County of Santa Clara

FILE NUMBER: PLN20-081 R2
SUBJECT: Architecture and Site Approval (ASA) and Grading Approval –
Land, Buildings & Real Estate (LBRE) Replacement Building
SITE LOCATION: 560 Fremont Road, CA 94305
DATE RECEIVED: 02/02/2021

Subject: Land, Buildings, and Real Estate (LBRE) Replacement Building – Traffic Reports Peer Review of Resubmittal

C9.0

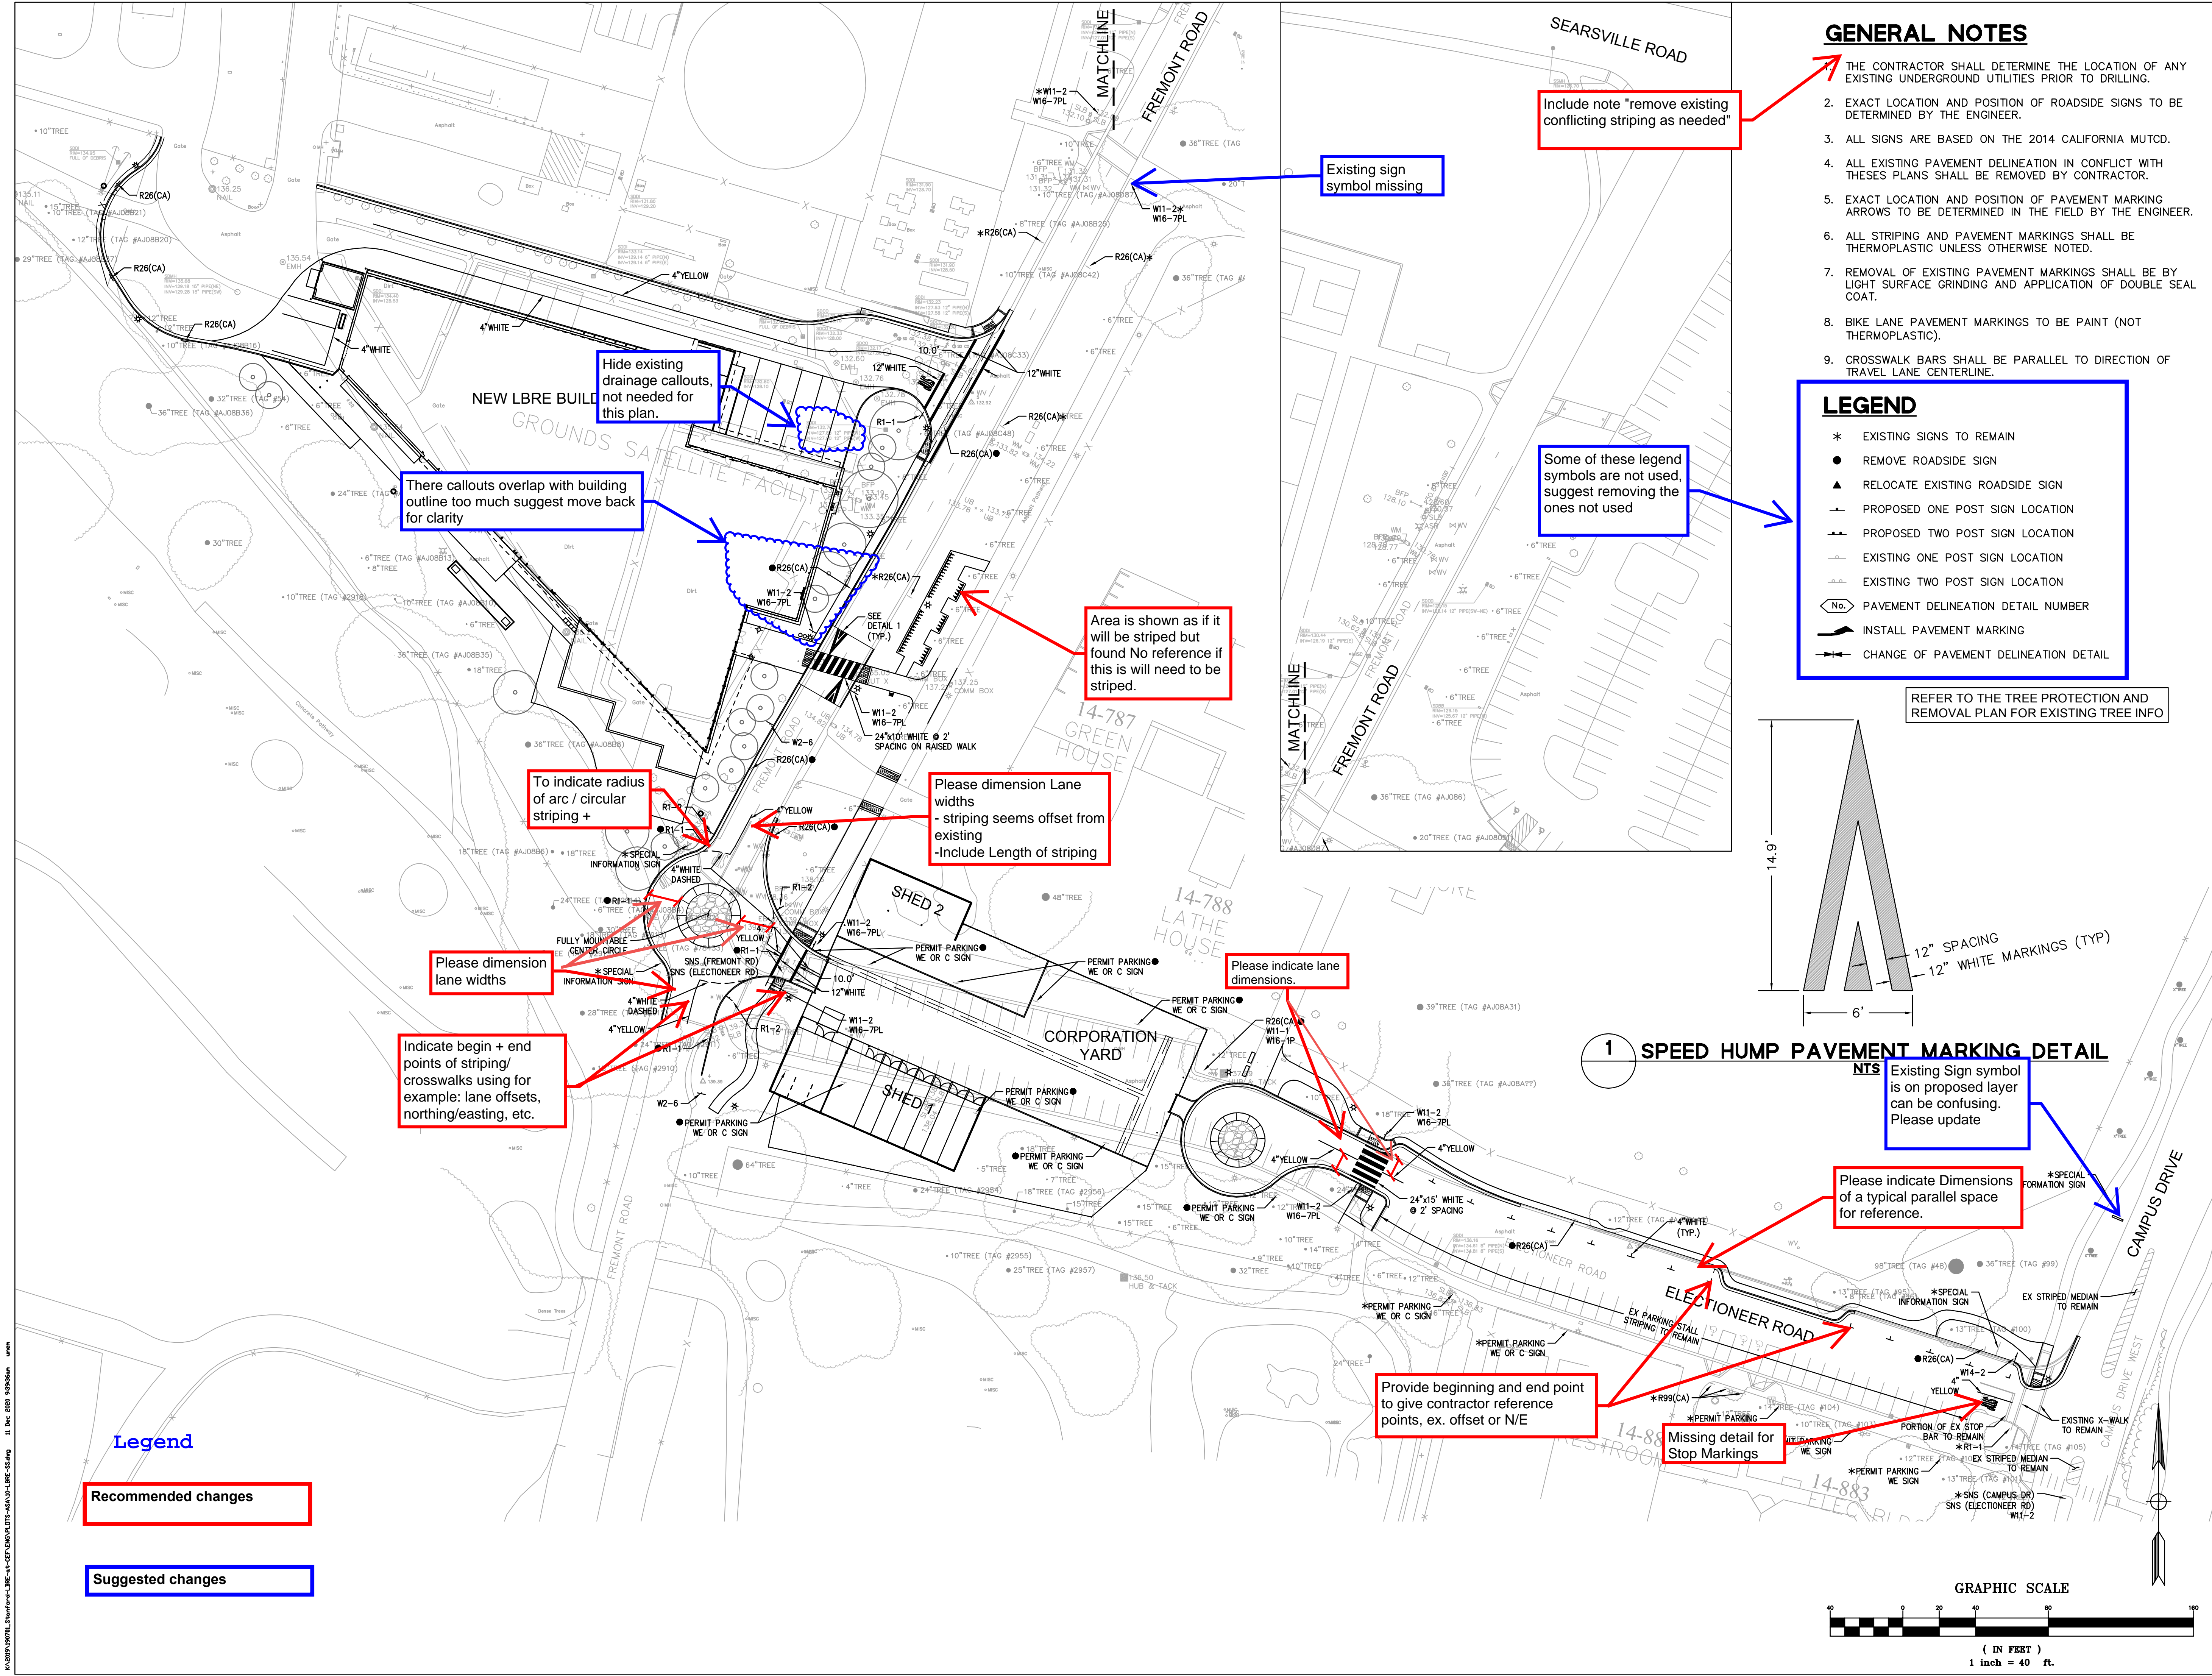
1. The resubmittal materials were provided to the County traffic consultant AECOM for peer review. AECOM provided the attached evaluation memo dated March 1, 2020 with additional submittal requirements. Please provide an updated Local Access and Circulation Study and revised sheet C9.0 (signing and striping plan) in response to the attached AECOM memo. Include a response letter describing the changes to the study and sheet C9.0.

Regarding the signing and striping plan submitted, AECOM has comments to meet the CA MUTCD³ guidelines. Providing this information will permit us to complete our peer review to make sure the plans are in compliance.

Plan C9 – see attached file with mark up. In summary, the plan has

- Missing symbols in both drawings and legend
- Missing dimensions, striping, and curvature; beginning and end points of features; standard and critical notes from list
- Missing dimensions need to conform with the narrative and circulation report (i.e., 20-foot lane widths, as cited on page 16)
